ADDENDUM NO. 1 TO PROJECT NO. M3063

**CONSTRUCTION WORK
REHABILITATE PATIO ROOF
CAPITAL DISTRICT PSYCHIATRIC CENTER
75 NEW SCOTLAND AVENUE
ALBANY, NY**

May 27, 2016

PARTIAL ROOF PLAN - UNIT 'B' PATIO REMOVALS PLAN

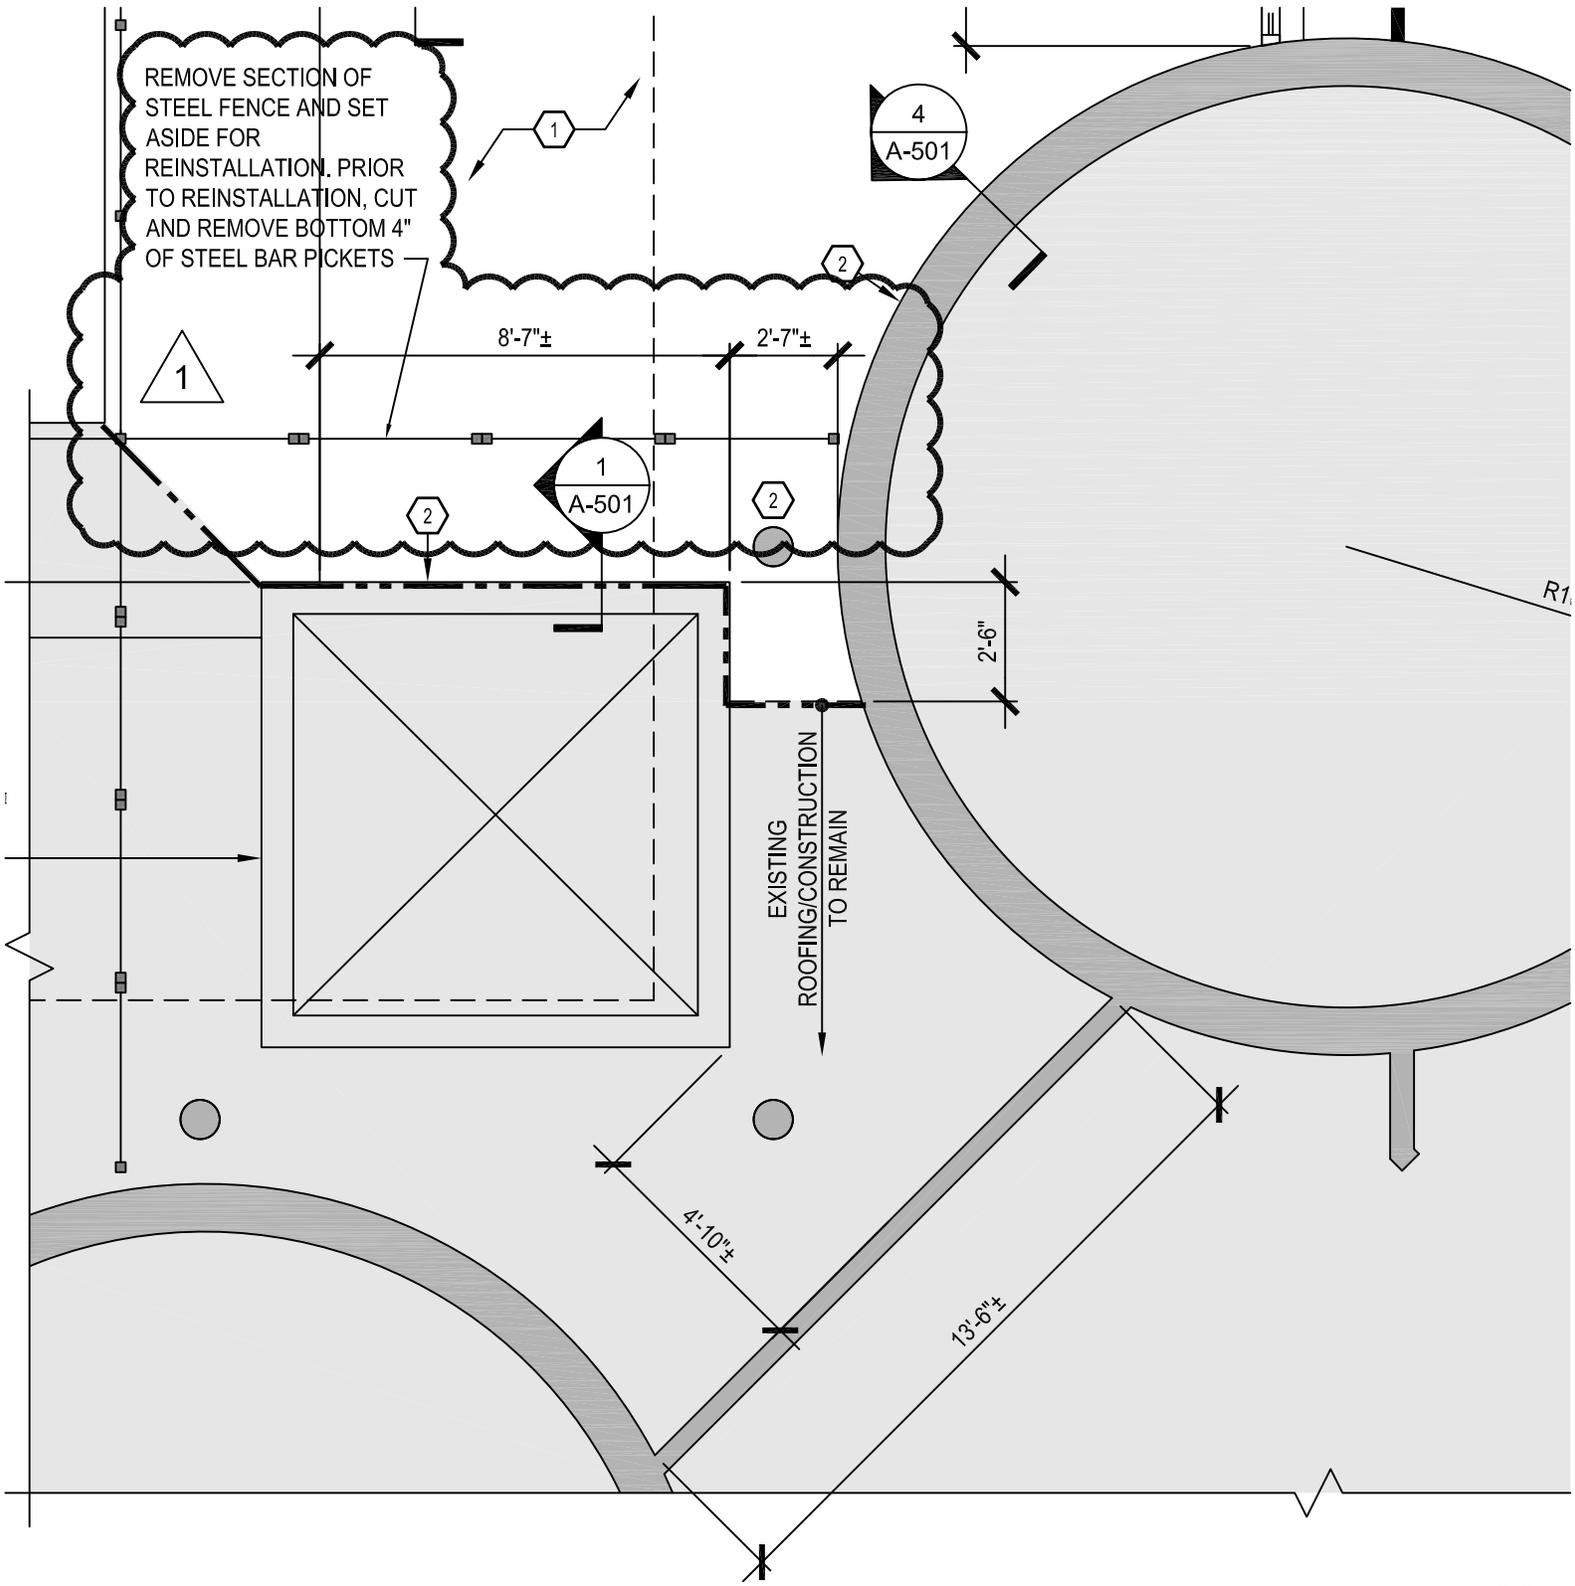
3. Drawings A-101 & A-102:
 - a. At Unit ‘B’ and Unit ‘E’ patios, temporarily remove section of existing steel fence and set aside for reinstallation. Prior to reinstallation, remove bottom 4” of steel bar pickets.

REMOVE SECTION OF STEEL FENCE AND SET ASIDE FOR REINSTALLATION. PRIOR TO REINSTALLATION, CUT AND REMOVE BOTTOM 4" OF STEEL BAR PICKETS
